Docket No. 50-336
B18294

Millstone Nuclear Power Station, Unit No. 2
Response to a Request For Additional Information Regarding Proposed Revision to
Final Safety Analysis Report
Fuel Centerline Melt Linear Heat Rate Limit (PLAR 2-00-2)

**Response to a Request For Additional Information Regarding Proposed Revision
to Final Safety Analysis Report
Fuel Centerline Melt Linear Heat Rate Limit (PLAR 2-00-2)**

↑
figure 13

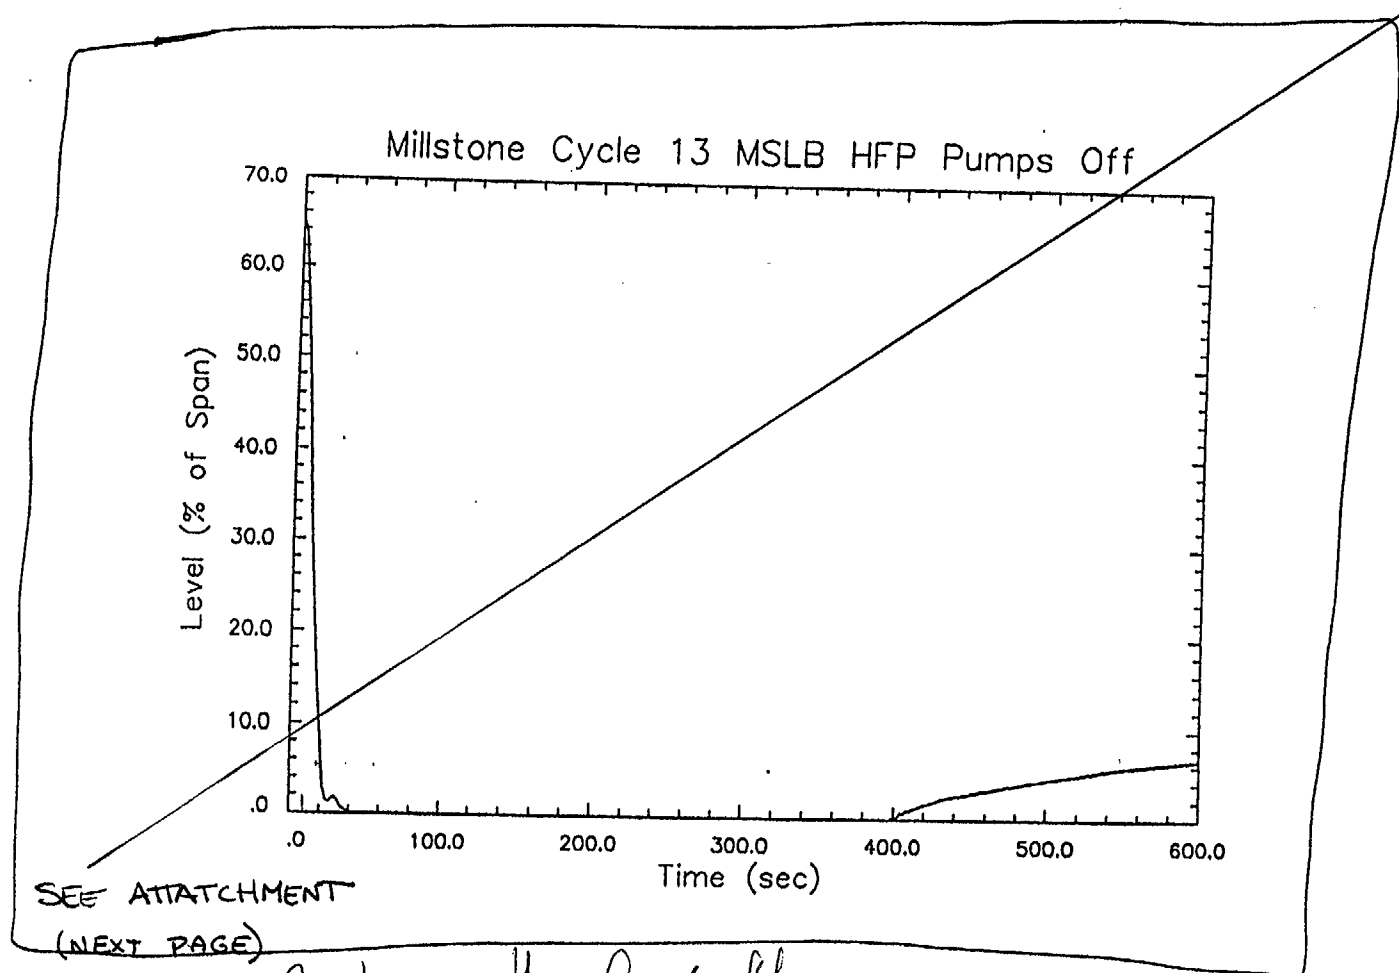
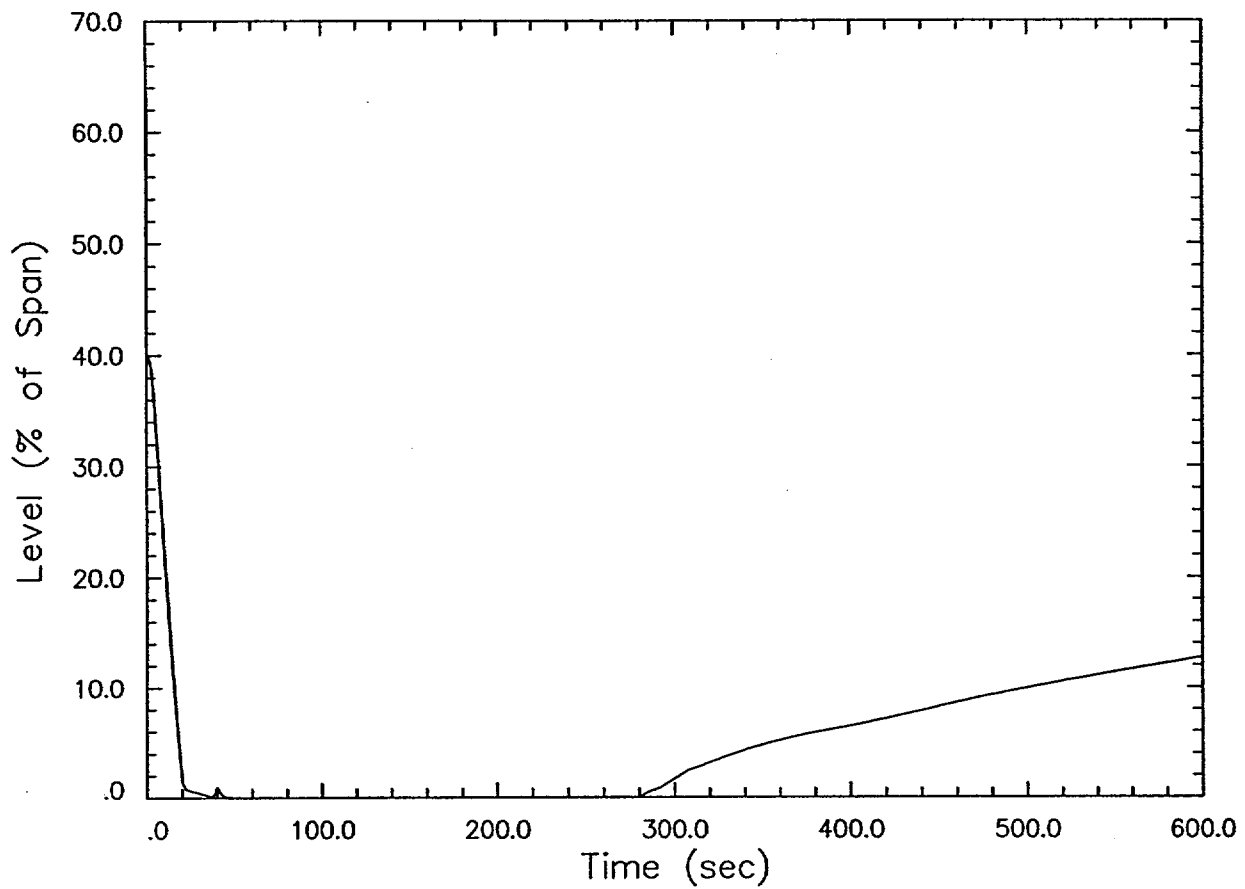
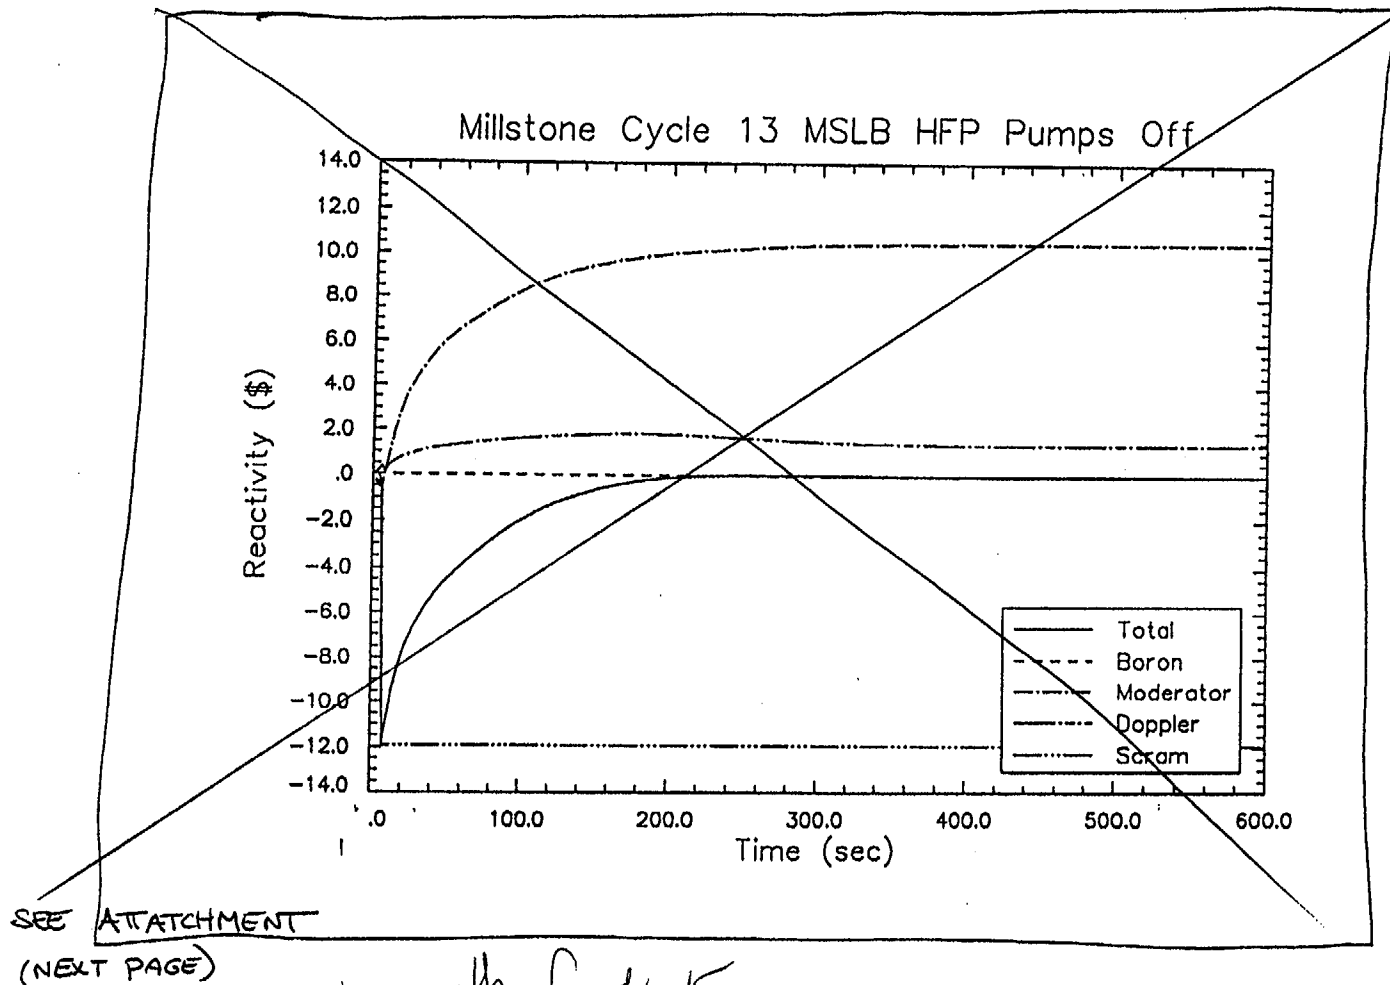
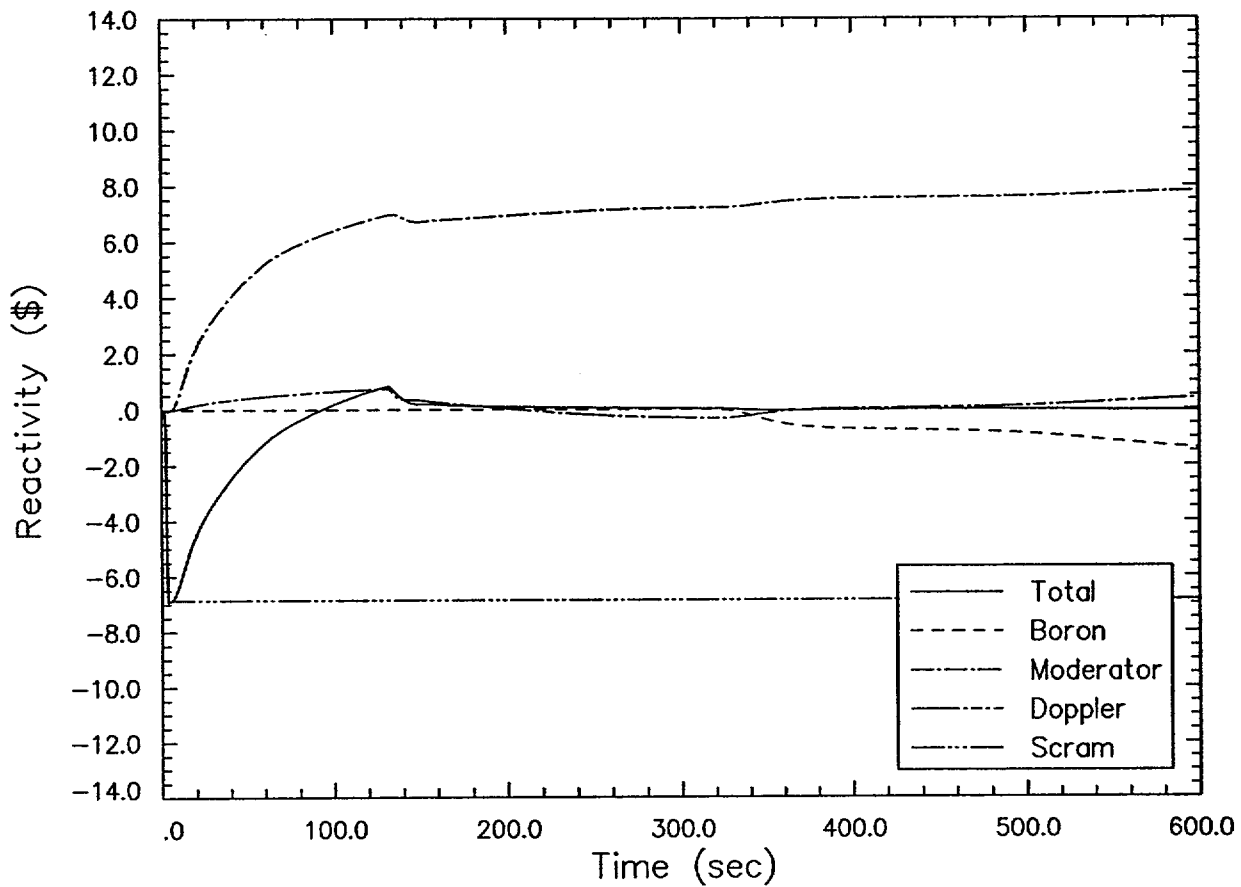
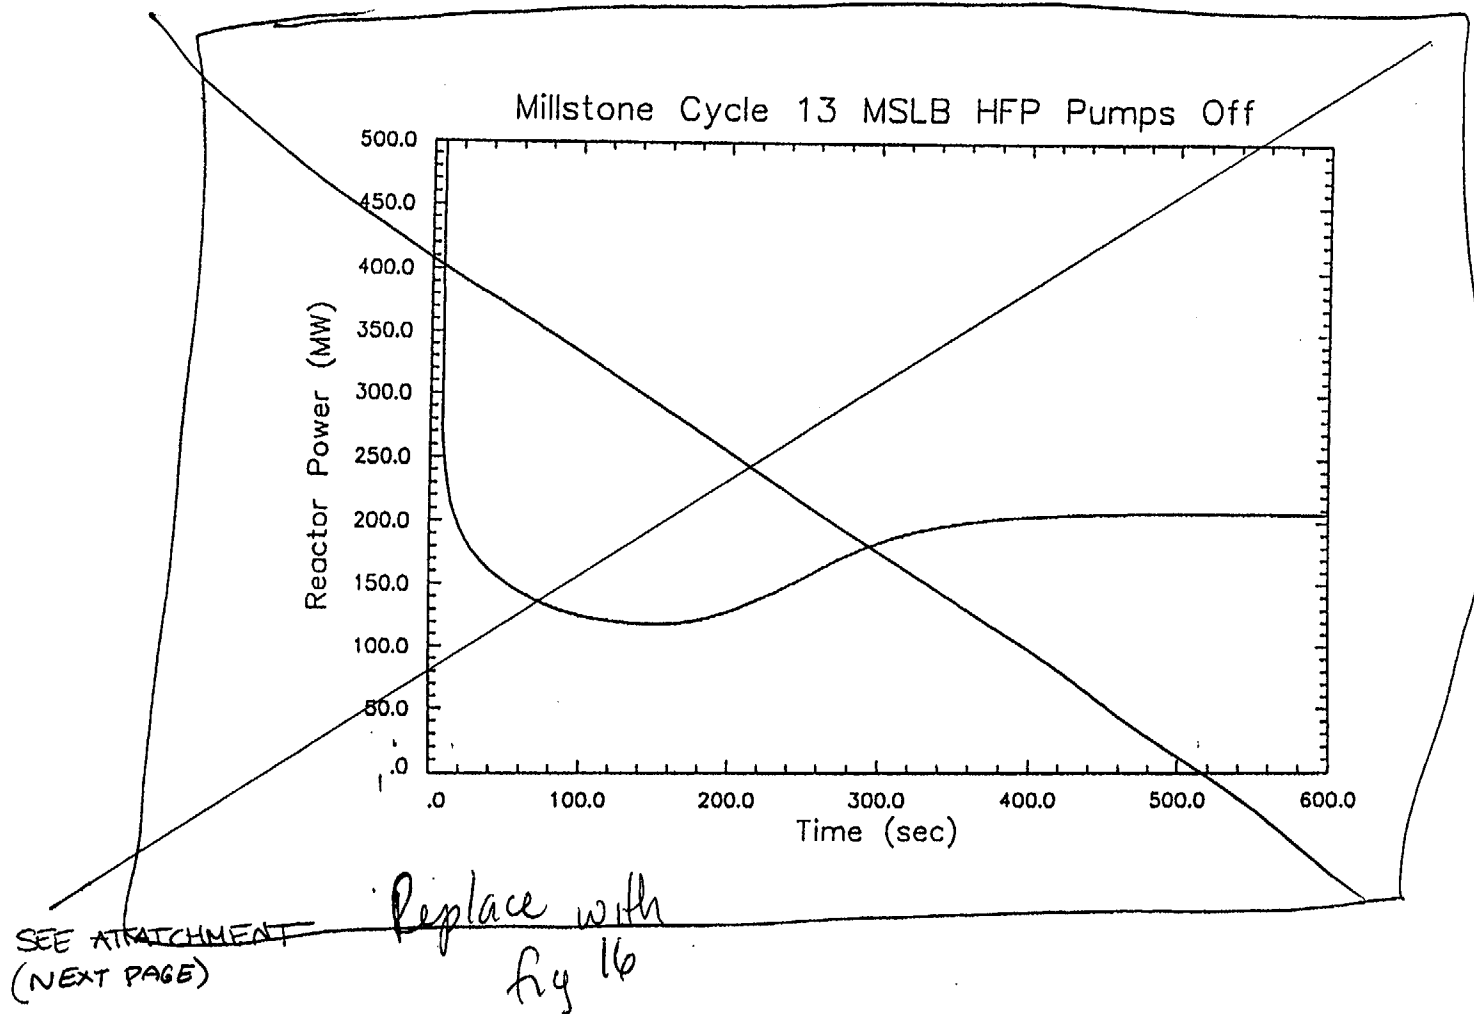
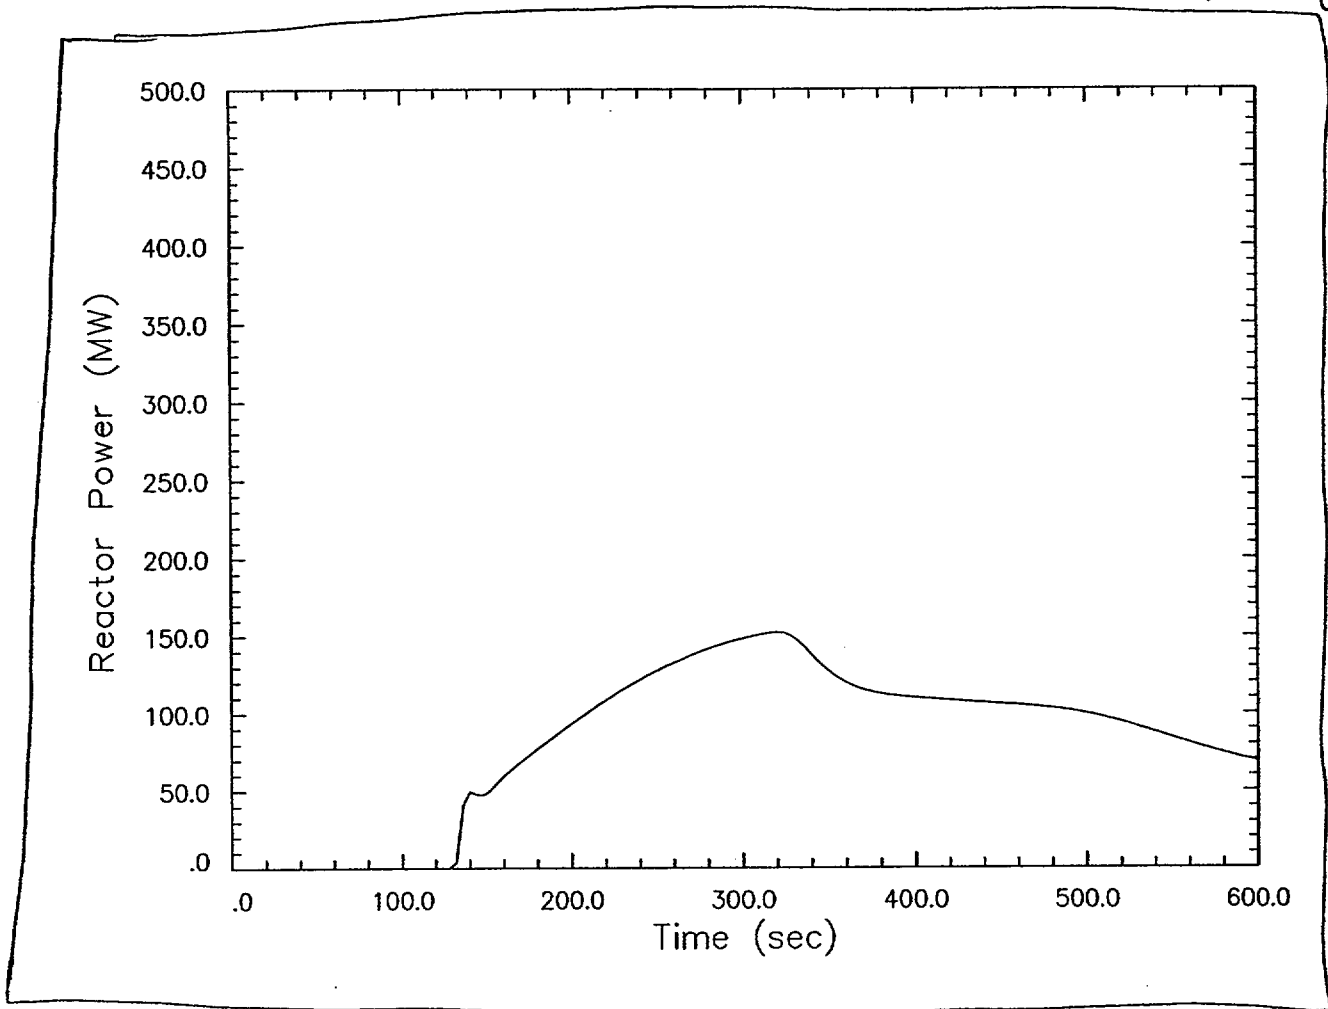
Section 14.1.5.2.6.2 refers to Figs. 14.1.5.2-10 through 14.1.5.2-16 and Table 14.1.5.2-8 as representative of the HZP SLB event outside containment. However, these figures and table previously referred to the HFP event. Should they be revised accordingly?

The cited figures and table have been updated by an earlier FSAR change associated with the Cycle 14 reload design change. To provide more clarification, Attachment 2 includes a markup of the FSAR Section 14.1.5, including the associated tables and figures. This attachment includes the changes to FSAR Section 14.1.5 associated with the Cycle 14 SLB reanalyses, and the proposed changes associated with the change to a cycle specific linear heat rate limit. The changes associated with the Cycle 14 SLB reanalyses are identified by FSAR Change Numbers 00-MP2-23 and 00-MP2-39 in the attachment. The proposed changes associated with the cycle specific linear heat rate limit are identified by FSAR Change Number 00-MP2-38 in the attachment.
